MONROE COUNTY, NEW YORK

ADDENDUM NO. 2

**MONROE COMMUNITY COLLEGE
2011 WINDOW REPLACEMENT AND CONCRETE/BRICK REPAIR
DECEMBER 2010
Bids Due: January 6, 2010 at 2:00 PM,**

Prepared by:
DeWolff Partnership Architects LLP
151 St. Paul Street
Rochester, New York 14604

1-107 REV 2-21

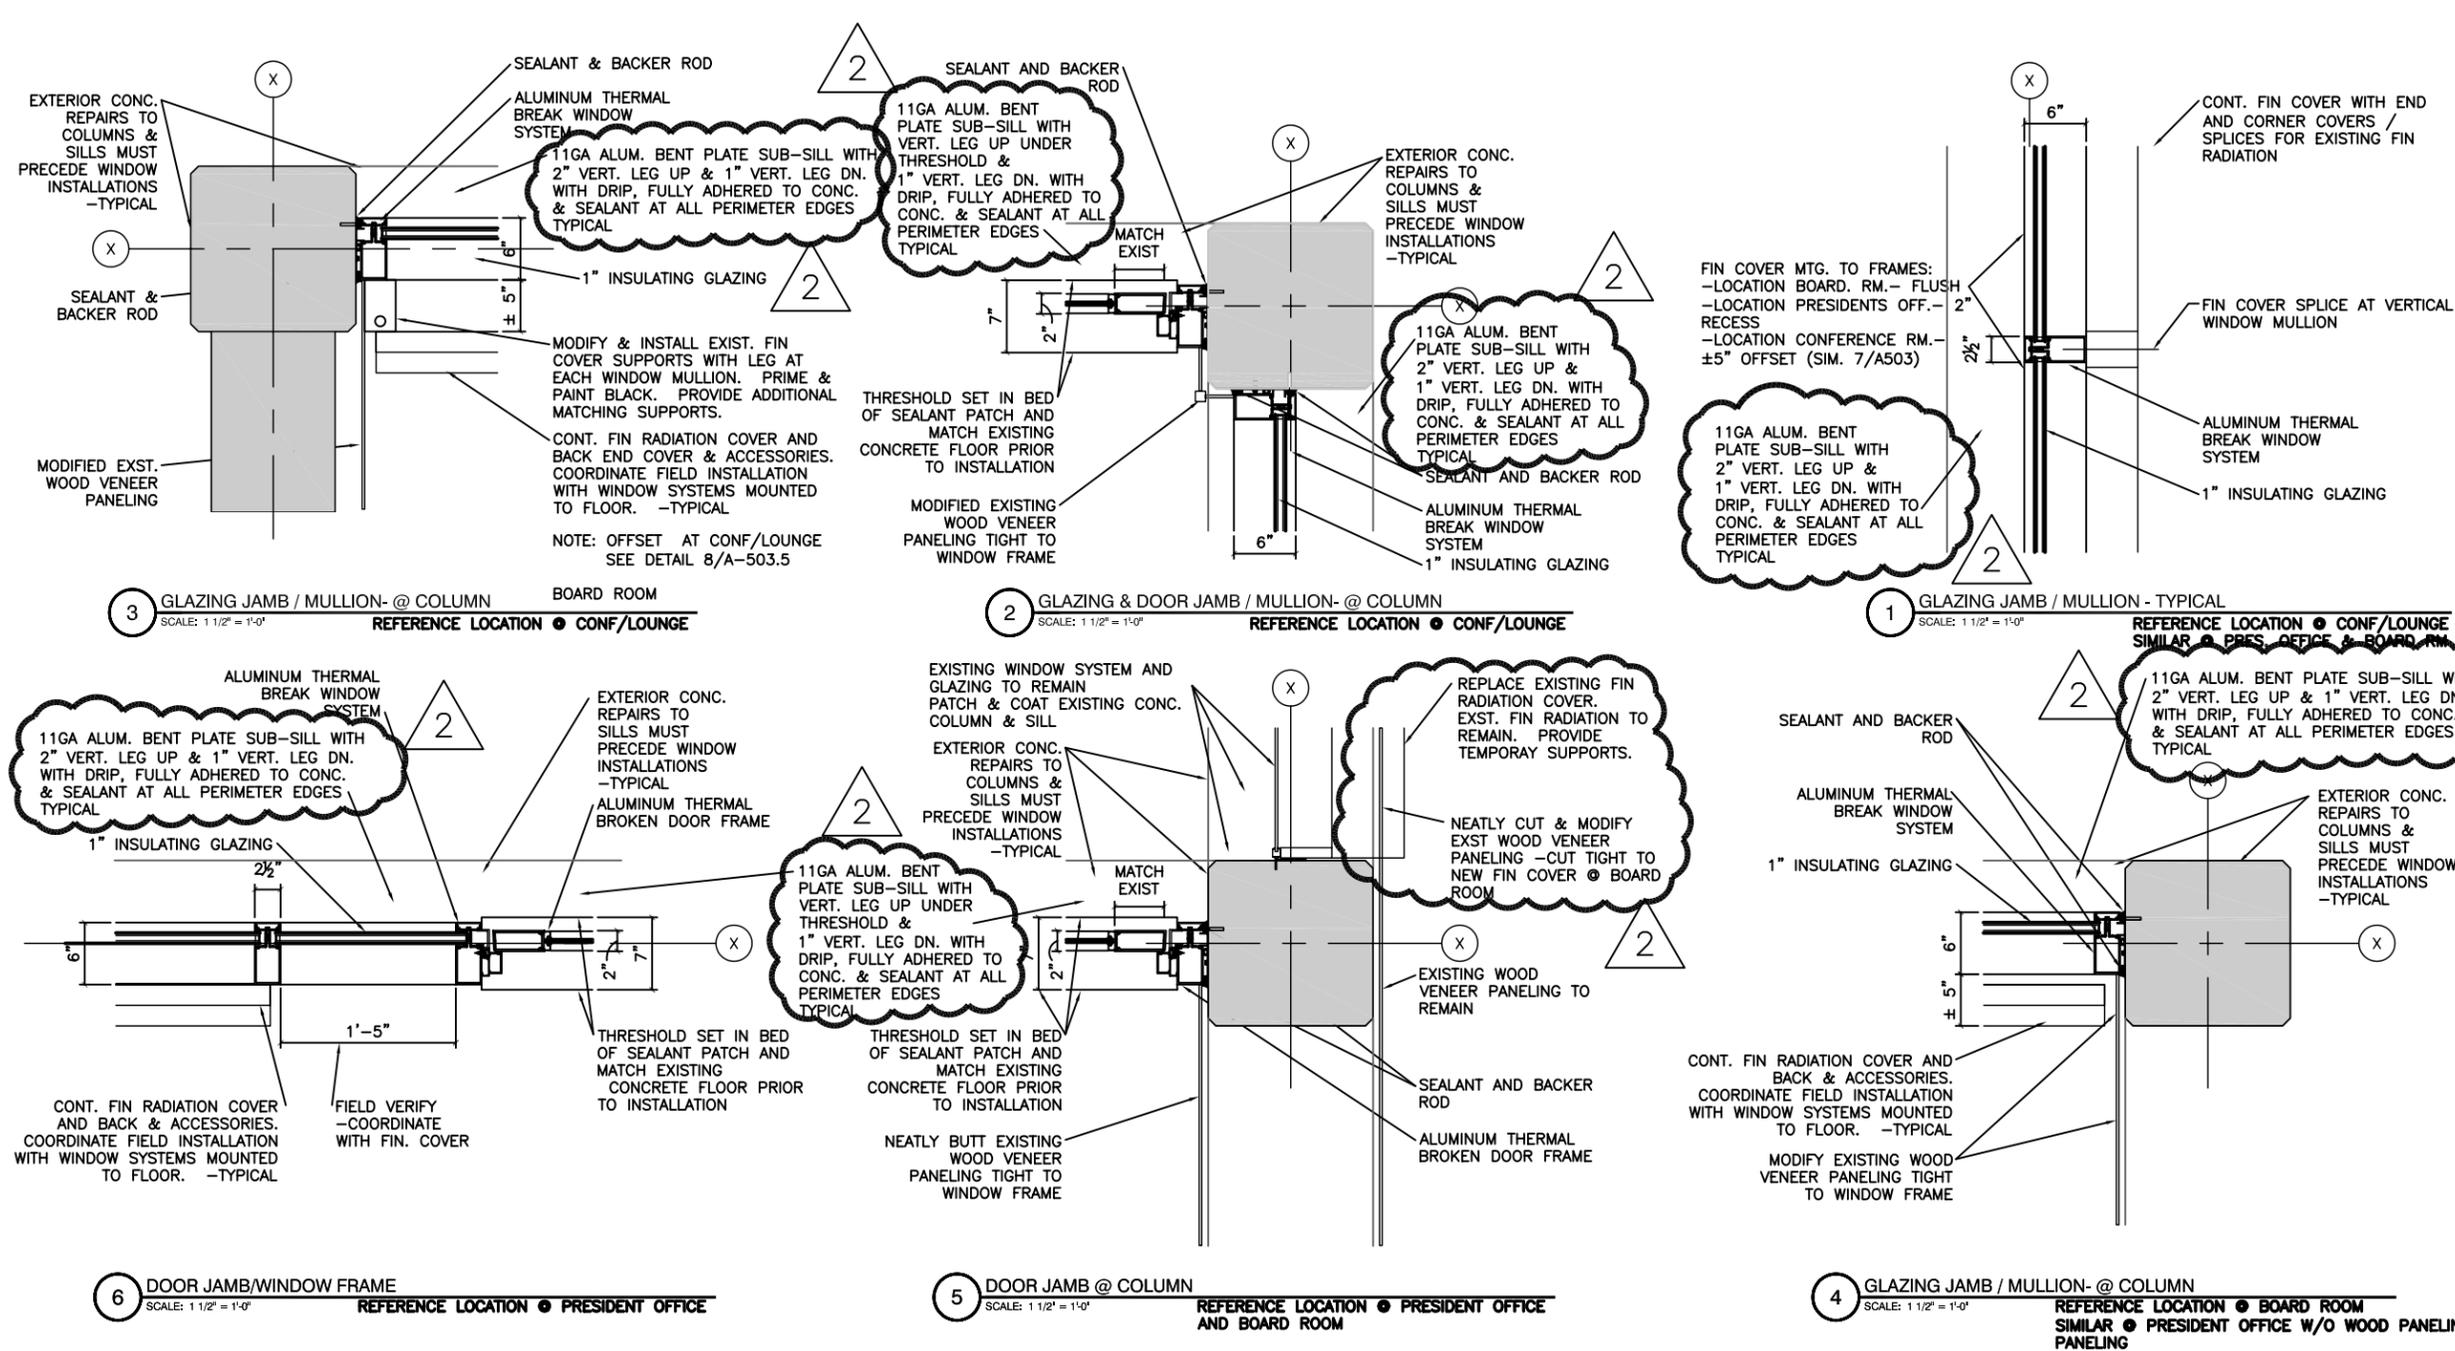
2-21 Details 1, 2, 3, 4, 5 & 6 /A-503.5:
ADD: REPLACE DETAILS 1, 2, 3, 4, 5 & 6 /A-503.5 WITH ATTACHED DETAILS 1, 2, 3, 4, 5 &
6, AS FOUND ON ADDENDUM 2 DRAWING 1-107, REVISION 2-21.

1-108 REV 2-22

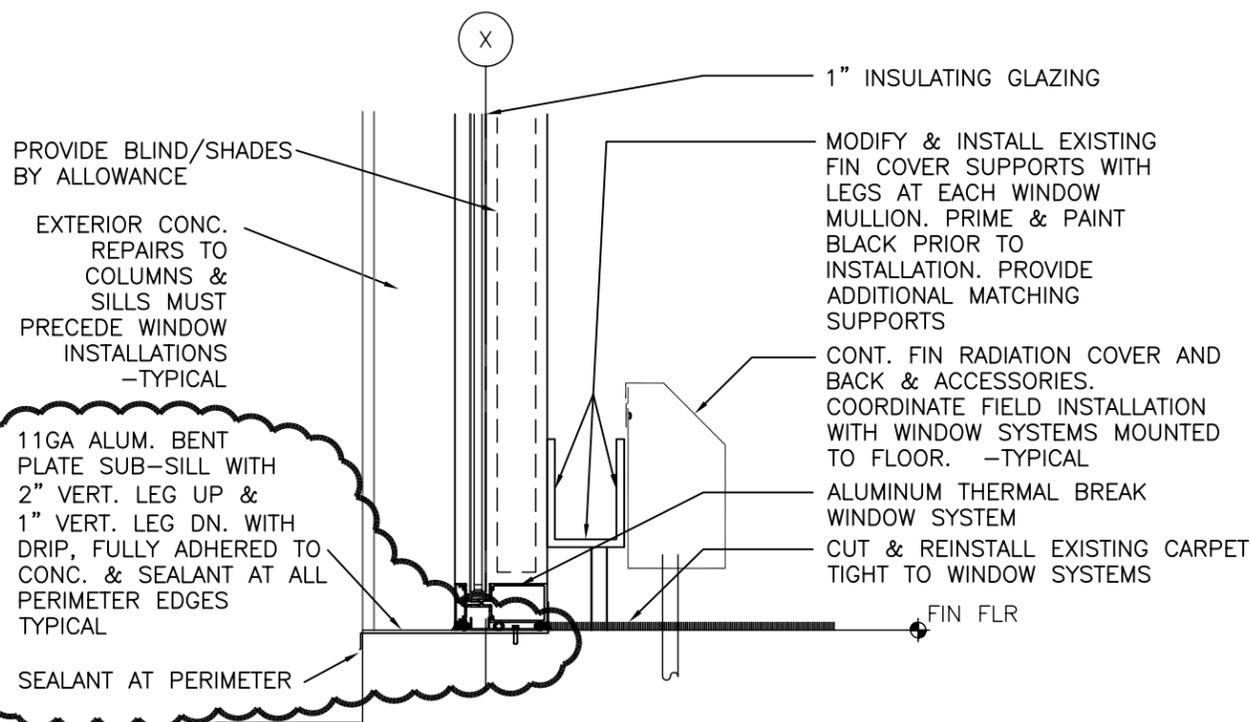
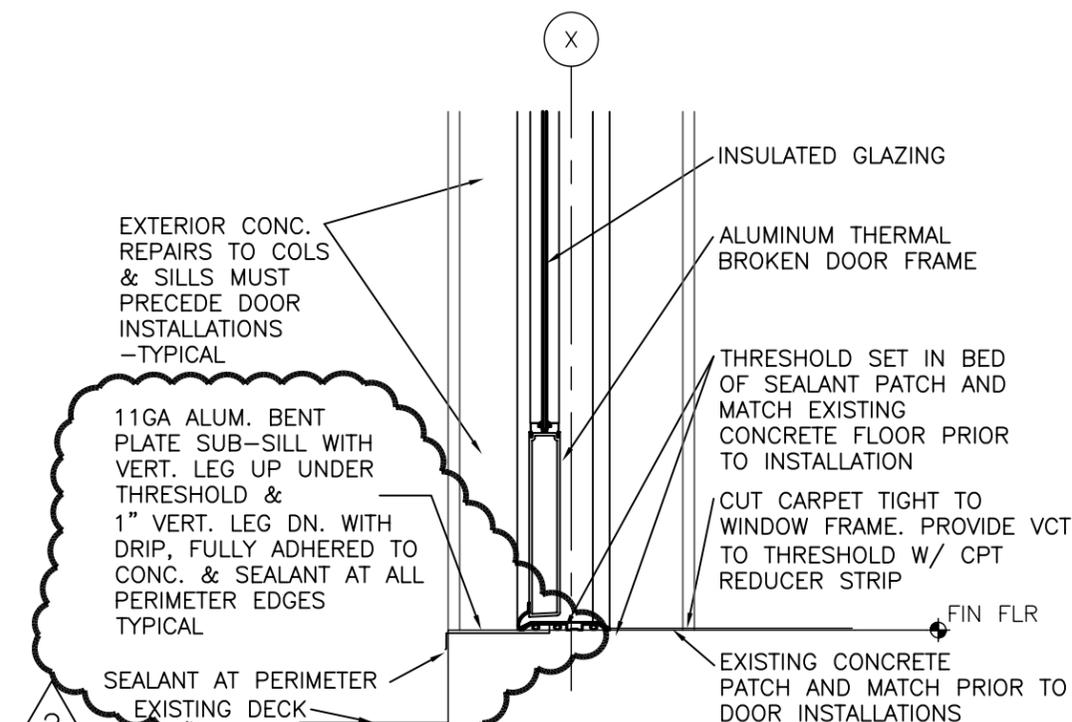
2-22 Details 7 & 8 /A-503.5:
ADD: REPLACE DETAIL 7 & 8/A-503.5 WITH ATTACHED DETAILS 7 & 8, AS FOUND ON
ADDENDUM 2 DRAWING 1-108, REVISION 2-22.
